CITY OF ROOSEVELT PARK
City of Roosevelt Park
PLANNING COMMISSION
AGENDA
September 25, 2023
6:00 p.m.

6. New Business
 - a. Site Plan Review-3145 Henry Street-Consumers Credit Union

**Subject: Consumers Credit Union Branch, 3145 Henry Street
Site Plan Review**

Re: Consumers Credit Union
Site Plan Review Response

A201
EXTERIOR ELEVATIONS

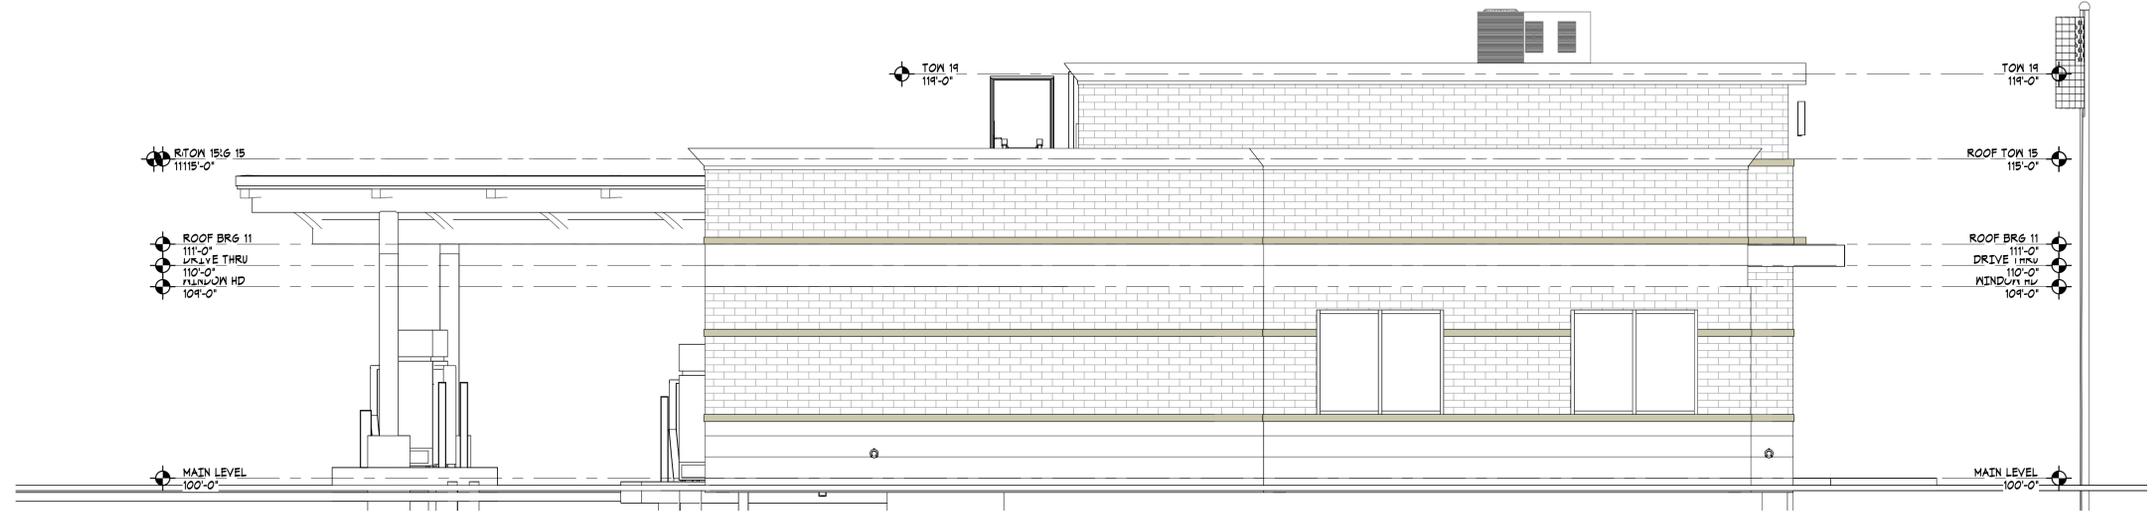
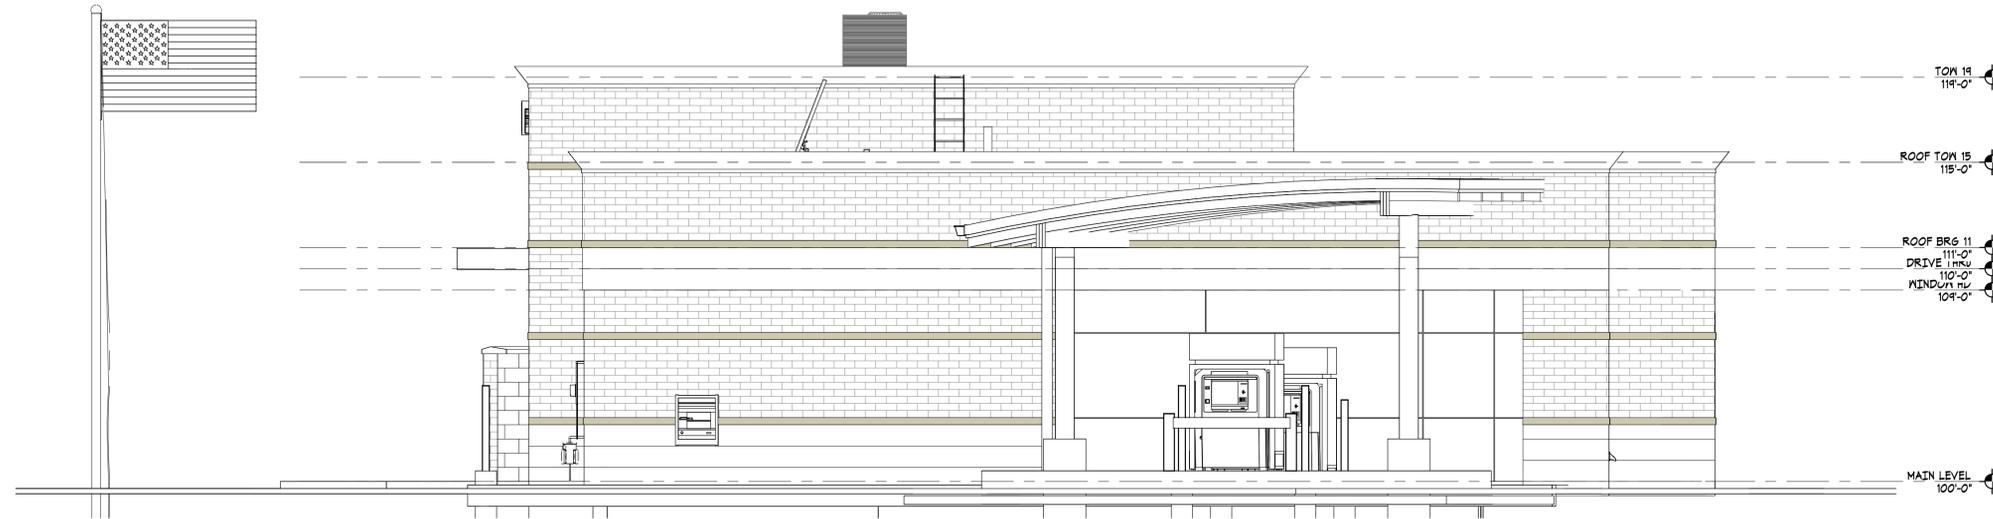
- e. **Building Height. The maximum building height is 35 feet.** The building elevations demonstrate a roof height of 15 feet and an additional 4-foot-tall parapet, for a total of 19 feet. The elevations comply with this requirement.
- f. **Lot Coverage. The maximum lot coverage is 35%.** The total lot area as stated on the plan is 50,803.52 sf. 4.5% (2,217 sf) will be building area, so the lot coverage standard is met.

The applicant proposes two identical wall signs on the north and east sides of the building which will be mounted on the roof parapet. The elevations do not provide the exact dimensions of the signage. Based on other dimensions provided the signage appears to be compliant, but the applicant should either provide the dimensions of the signage to be approved with the Site Plan, or should submit for a sign permit separately from the Site Plan Approval.

3. The applicant proposes two identical wall signs on the north and east sides of the building which will be mounted on the roof parapet. The elevations do not provide the exact dimensions of the signage. Based on other dimensions provided the signage appears to be compliant, but the applicant should either provide the dimensions of the signage to be approved with the Site Plan, or should submit for a sign permit separately from the Site Plan Approval.

SITE DEVELOPMENT PLAN
SCALE: 1" = 20'

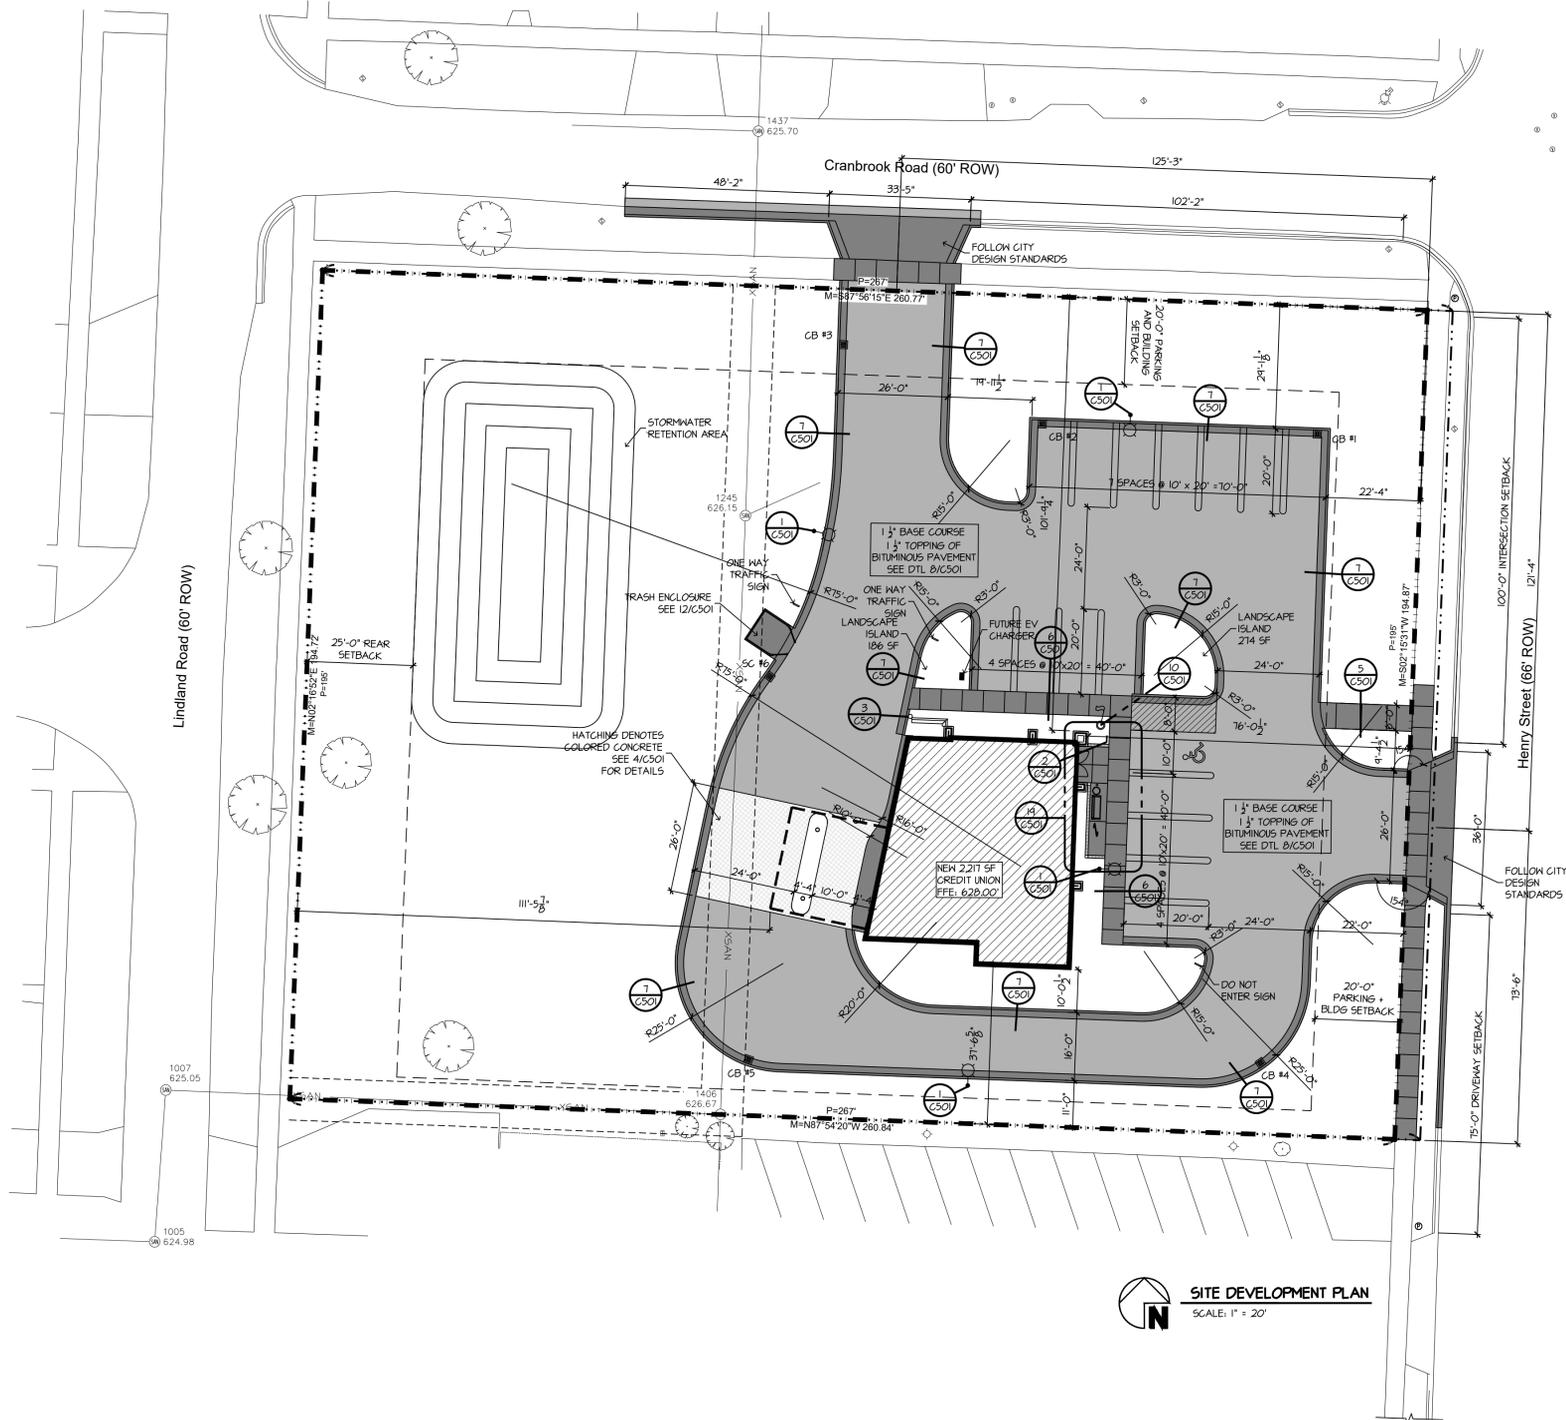
- b. **Front Setback: 20 feet** The minimum front setback is 20 feet. As it is a corner lot, both the East and North sides of the property must comply with the front setback. The site plan demonstrates a 22’ setback from Henry Street and a 29’ setback from Cranbrook Road, and complies with the requirements.

- c. **Rear Setback: 25 feet** Because the lot is a corner/through lot along three streets, the remaining West lot line will be considered a rear lot line according to Section 3.9.C. The site plan shows compliance with this setback requirement.

The two-way aisles are 24 feet wide, meeting City requirements. The one-way aisles for drive-through access are required to be a minimum of 12 feet wide, and the site plan indicates they will be 16 feet wide at their narrowest point. The access drive dimensional requirements are met.

- c. **Barrier-Free Parking.** One barrier-free space is required. The required space is included on the plan and conforms with state requirements for dimensions and location.
- d. **Loading Docks.** According to Section 12.13, office uses with more than 2,000 feet of floor area are required to provide one loading and unloading space, at least 12 feet wide, 40 feet long, and with 15 feet of overhead clearance. The Credit Union will be 2,217 square feet, and therefore must include a loading and unloading area, which may not occupy required parking spaces. The applicant must also submit specifications showing required loading space and the means of ingress, egress, and interior circulation. This requirement has not been met. No loading area is identified on the site plan.

No walkway is provided from Cranbrook Road or Lindland Road. We would support the Planning Commission considering a walkway from Cranbrook sufficient to meet the requirement for both Lindland and Cranbrook, since residents on Lindland can easily walk to Cranbrook to access the site, and an additional walkway to the rear of the building is not desirable for Consumers or for the nearby residents. A sidewalk along the east side of the driveway to Cranbrook, with a crosswalk to the building, would allow for efficient and safe pedestrian access from the north and west.

Section 11.9.1.4 requires that parking lots and driveways providing access to corner lots shall be required to gain *sole access* from the lesser traveled of the two (2) intersecting streets, but allows the Planning Commission to waive that limitation, and we recommend that they do so in this case, because there is already an existing driveway to Henry Street, and the new one will be more conforming than the old one (see below).

- g. Drive-Through Requirements.** Section 10.6.B.1 requires a minimum of four stacking spaces for each drive-through teller operation on site. Consumers Credit Union will have two drive-through ITMs. The site plan does not specifically identify stacking spaces. Based on the dimensions provided by the site plan it appears that there will be sufficient stacking space.

- b. Freestanding sign.** There is an existing freestanding sign on the property. The sign does not appear on the Site Plan. Will the sign be re-used for the Consumer's Credit Union? Is another freestanding sign proposed?

1. According to Section 12.13, office uses with more than 2,000 feet of floor area are required to provide one loading and unloading space, at least 12 feet wide, 40 feet long, and with 15 feet of overhead clearance. The Credit Union will be 2,217 square feet, and therefore must include a loading and unloading area, which may not occupy required parking spaces. The applicant must also submit specifications showing required loading space and the means of ingress, egress, and interior circulation. This requirement has not been met. No loading area is identified on the site plan.
A loading area will be identified in the parking area at the northeast corner. The site contains 5 parking spaces above the required number. 4 spaces will be shown as dual use (parking and loading). It is our opinion this loading area will be sparsely used based on other locations.

2. No walkway is provided from Cranbrook Road or Lindland Road. We would support the Planning Commission considering a walkway from Cranbrook sufficient to meet the requirement for both Lindland and Cranbrook, since residents on Lindland can easily walk to Cranbrook to access the site, and an additional walkway to the rear of the building is not desirable for Consumers or for the nearby residents. A sidewalk along the east side of the driveway to Cranbrook, with a crosswalk to the building, would allow for efficient and safe pedestrian access from the north and west.
A walkway as described can be added to access Cranbrook Road. This will also provide access to the northern parking spaces. Landscaping will also be added to this walkway to meet the ordinance.

SITE PHOTOMETRIC PLAN
SCALE: 1" = 20'

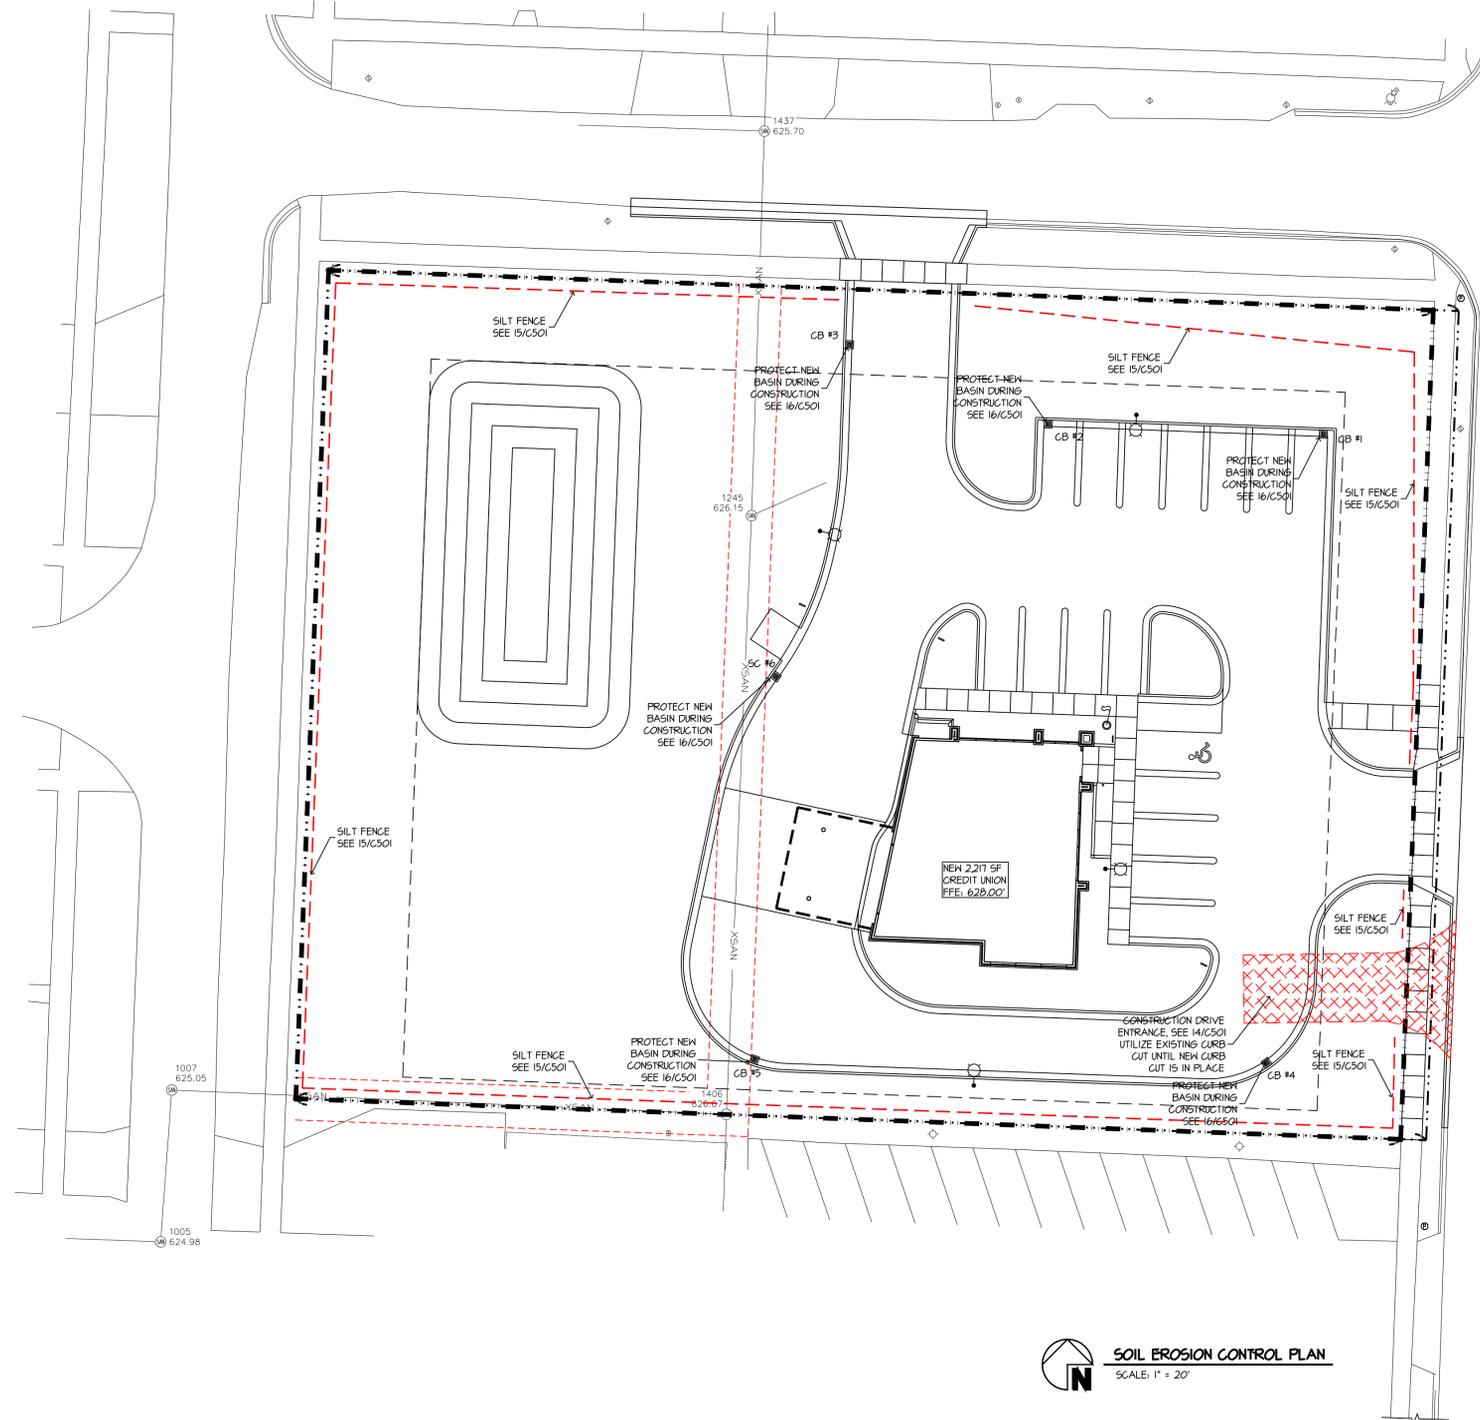
- ii. *Light poles and/or fixtures and flag poles shall not exceed thirty (30) feet in height. The Planning Commission may permit a higher light fixture in selected locations for larger parking lots where existing or planned residential areas will not be affected. A flag pole is proposed, and will comply with the height limit. See below.*

- a. **Lighting provided for security or visibility on any site shall be shielded to reduce glare and shall be so arranged and maintained as to direct the light away from any Residential District or use.** *The fixture design meets this requirement. According to the photometric plan submitted by the applicant, the design will hit 0.0 footcandles along Lindland and the portion of Cranbrook where the house is across the street. The lot line abutting the home to the southwest includes some areas as high as 0.2 footcandles and must be reduced to 0.0.*
- b. **Light fixtures shall be no higher than twenty (30) feet and shall be provided with light cut-off fixtures that direct light downward.** *The fixtures meet the height and design requirement.*

7. Lighting provided for security or visibility on any site shall be shielded to reduce glare and shall be so arranged and maintained as to direct the light away from any Residential District or use. The fixture design meets this requirement. According to the photometric plan submitted by the applicant, the design will hit 0.0 footcandles along Lindland and the portion of Cranbrook where the house is across the street. The lot line abutting the home to the southwest includes some areas as high as 0.2 footcandles and must be reduced to 0.0.

22 LANDSCAPE FORMS LOOP BIKE RACK
SCALE: 3/4" = 1'-0"

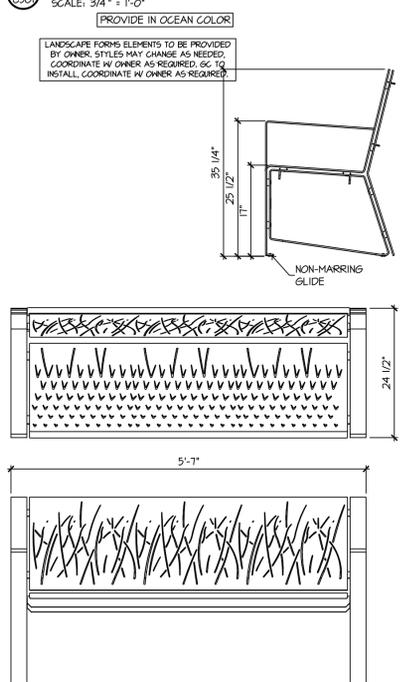
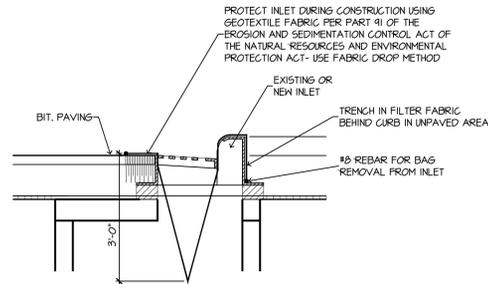
- g. **Community Amenities (11.6.B).** *Community amenities such as patio/seating areas, water features, art work or sculpture, clock towers, pedestrian plazas with park benches or other features located adjacent to the primary entrance to the building(s) are highly encouraged and may be calculated as part of the landscaping requirement. The design does not include any of the listed amenities. The Planning Commission should discuss options for amenities with the applicant.*

6. Community amenities such as patio/seating areas, water features, art work or sculpture, clock towers, pedestrian plazas with park benches or other features located adjacent to the primary entrance to the building(s) are highly encouraged and may be calculated as part of the landscaping requirement. The design does not include any of the listed amenities. The Planning Commission should discuss options for amenities with the applicant.

A bike rack and seating bench are located to the left of the main entrance and detailed on sheet C501. Our hope is these items can be counted for the community amenities.
